DEVELOPMENT ASSESSMENT PANEL REPORT

<b>Application No.</b>	DA/2024/0631
<b>Address</b>	500-502 Marrickville Road DULWICH HILL
<b>Proposal</b>	Partial demolition of existing structures, retention of the front portion of the building and construction of a four storey mixed use building (shop top housing), including ground floor commercial space and six residential units above.
<b>Date of Lodgement</b>	31 July 2024
<b>Applicant</b>	Vida Builders & Developers Pty Limited
<b>Owner</b>	Mr Garry Contos Mr Anthony Contos
<b>Number of Submissions</b>	Notification: 0 Renotification: 0
<b>Cost of works</b>	\$2,280,743.65
<b>Reason for determination at Planning Panel</b>	Development to which <i>SEPP (Housing) 2021</i> - Chapter 4 Design of Residential Apartment Development applies.
<b>Main Issues</b>	<ul style="list-style-type: none"> <li>• Section 5.10 – Heritage Conservation</li> <li>• Part 2.5 – Equity of Access and Mobility</li> <li>• Part 2.10 – Parking</li> <li>• Part 8 – Heritage</li> </ul>

<b>Recommendation</b>	Approved with Conditions
<b>Attachment A</b>	Recommended Conditions of Consent
<b>Attachment B</b>	Plans of Proposed Development
<b>Attachment C</b>	Architectural Excellence a

Project No: P6312  
Sheet: A099  
Date: 17/01/2025  
Author: nev06

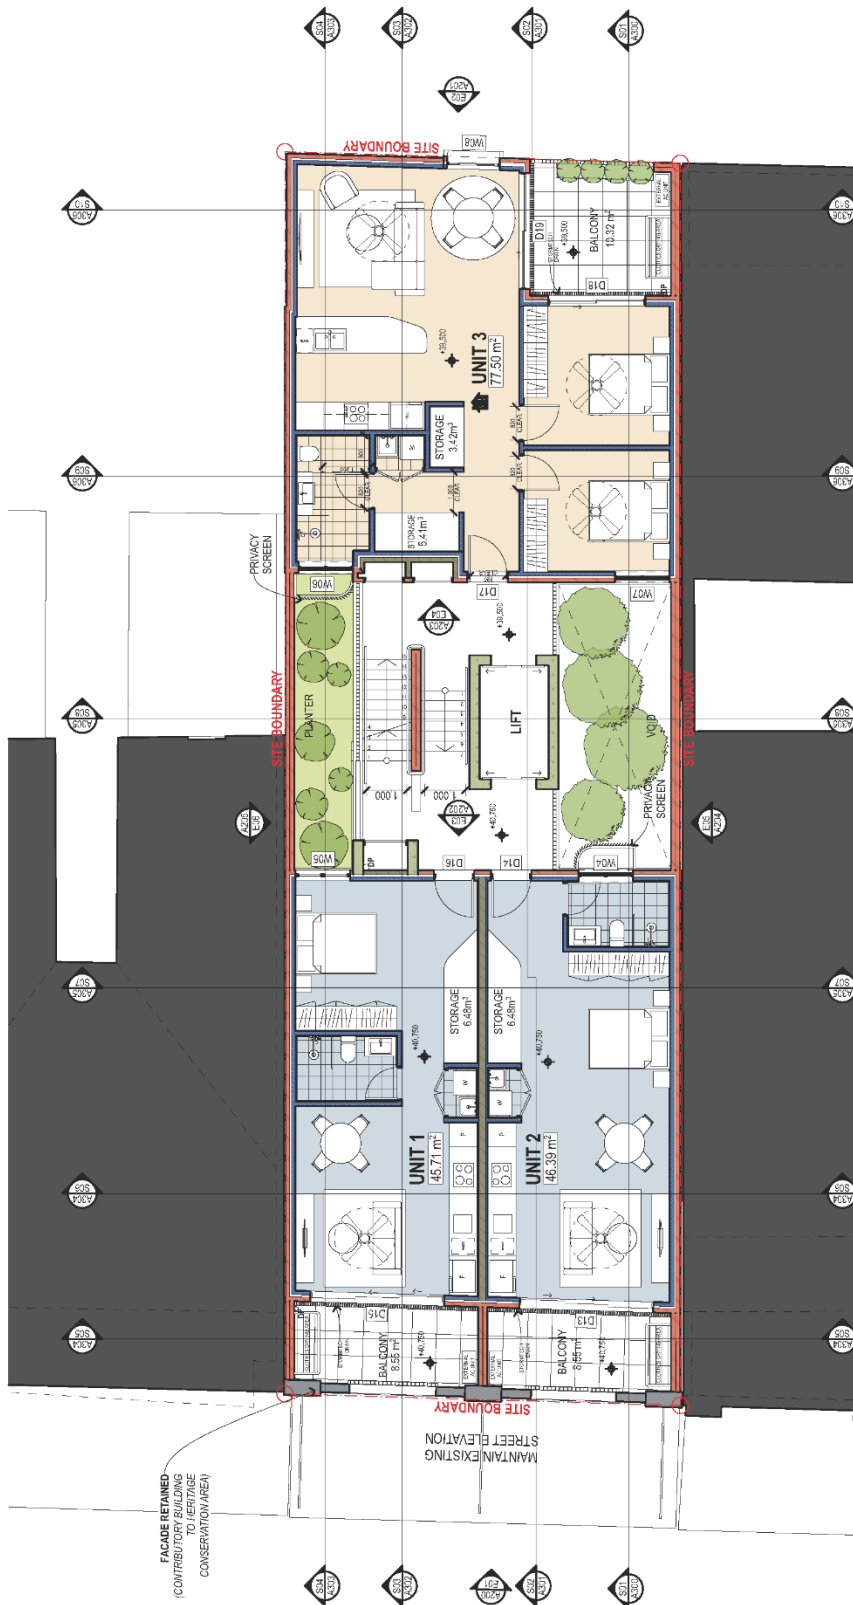
**Comment:** The development complies with the above requirement as 7.6% or 22.4sqm of deep soil is provided on site. However, the Basement Floor Plan indicates that the Stormwater Tank may be potentially located beneath a portion of the deep soil area; thus, rendering this portion as a planter, rather than deep soil planting. As such, a condition is included in the recommended requiring the relocation of the Stormwater Tank outside of the deep soil zone.
